Case File Number: PUD06010-R02

The purpose of this report is to provide information about the design components of the proposed Brooklyn Basin Project Modifications, and to seek any comments on the merits of the design from the Design Review Committee of the Planning Commission (DRC).

CITY OF OAKLAND PLANNING COMMISSION

Case File: PUD06010-R02-ER01
Applicant: Zarsion OHP
Address: Brooklyn Basin (formerly known as "Oak to 9th Avenue")
Zone: (PWD-4)/D-OTN, OS(RSP)

Planned and Proposed Tower Locations:

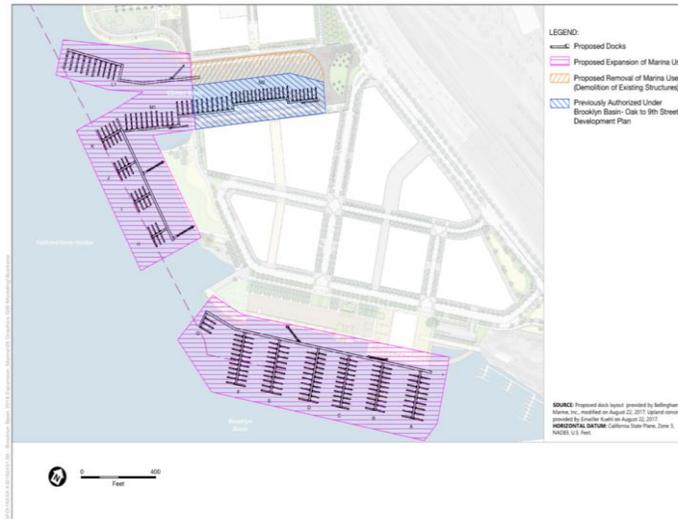
- **That the proposed design will create a building or set of buildings that are well related to the surrounding area in their setting, scale, bulk, height, materials, and textures:**
 - The proposed tower relocations would potentially intensify towers in the northwest portion of the project. Would the intensification of towers relate well to Gateway and South Parks, the Shadetree property, and the Fifth Avenue community? Would the intensification in this part of the site by one tower represent a substantial change from the planned development context?
 - *Staff believes that the relocation of a tower would not represent a change to the context surrounding Brooklyn Basin, and would not represent a*

- **That the proposed design will protect, preserve, or enhance desirable neighborhood characteristics;**
 - Would intensification of towers surrounding the Shadetree property and the Fifth Avenue community jeopardize the desirable neighborhood characteristics of those sites? The Shadetree property and Fifth Avenue community are both existing low-rise uses. Both sites are valued for fostering arts and culture within the Oakland community. The Shadetree property recently received permits for significant upgrades to further strengthen the legitimacy and permanency of creative uses at the site.
 - *Staff believes that the proposed intensification of towers adjacent to the two neighbors would not jeopardize the facilities or activities on those sites any more so than the planned project.*

Planned and Proposed Marina Expansion:

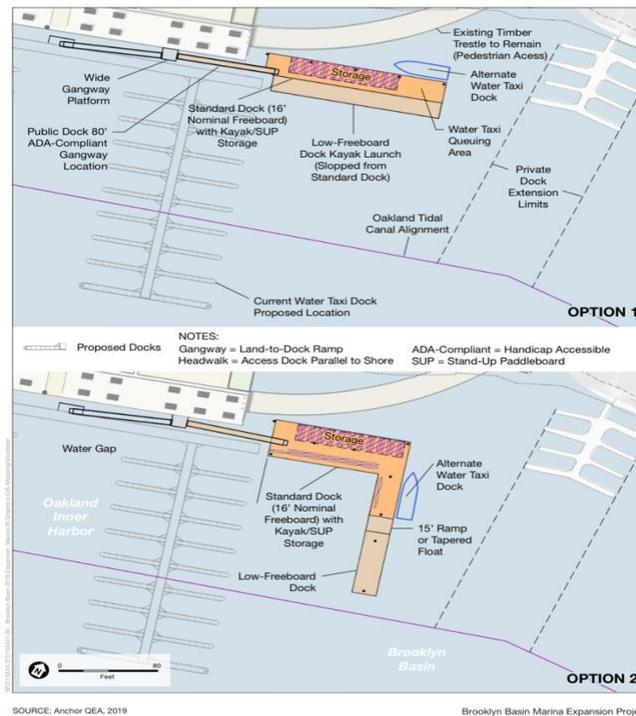
- *Do the expanded marina facilities relate well to South Park and Township Commons Park?*
 - *Do the marina and water taxi facilities fronting Township Commons Park, in particular, relate to the current design and use of Township Commons Park (which was not designed or constructed to provide access to a water taxi or marina facilities)?*

- *Would the water taxi facility, marina facilities and associated watercraft relate well to the setting of Township Commons Park and South Park?*

- **That the proposed design will be of a quality and character which harmonizes with, and serves to protect the value of, private and public investments in the area;**
 - *Do the expanded marina facilities harmonize with and contribute to the value of the new public parks they front, South Park and Township Commons Park?*
 - *Would access across City parks to the water taxi and marina facilities negatively affect the value of these City parks?*

Simulated Marina Expansion View:

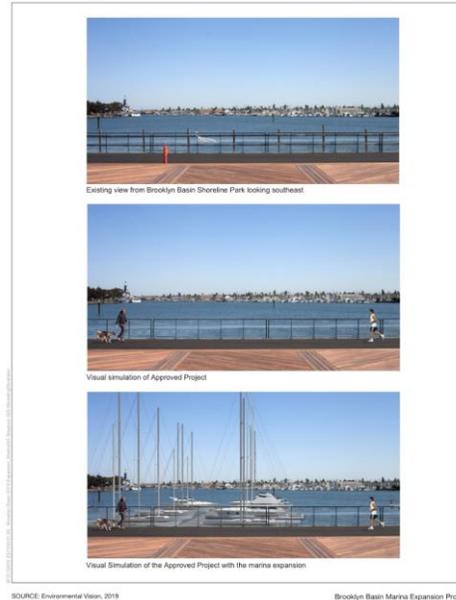
- How much parking is required to serve the marina and water taxi uses? Applicant should demonstrate demand and availability.
 - The applicant's renderings are inconsistent with the photo images shown in the same presentation. Boats and sailboat rigging will clutter and obscure the open views.

- Who was noticed for the PRAC meeting? Was the Measure DD Coalition notified?
 - The applicant renderings are unrealistic, relying on an imaginary muted color scheme for all improvements, and not showing slips at full capacity.
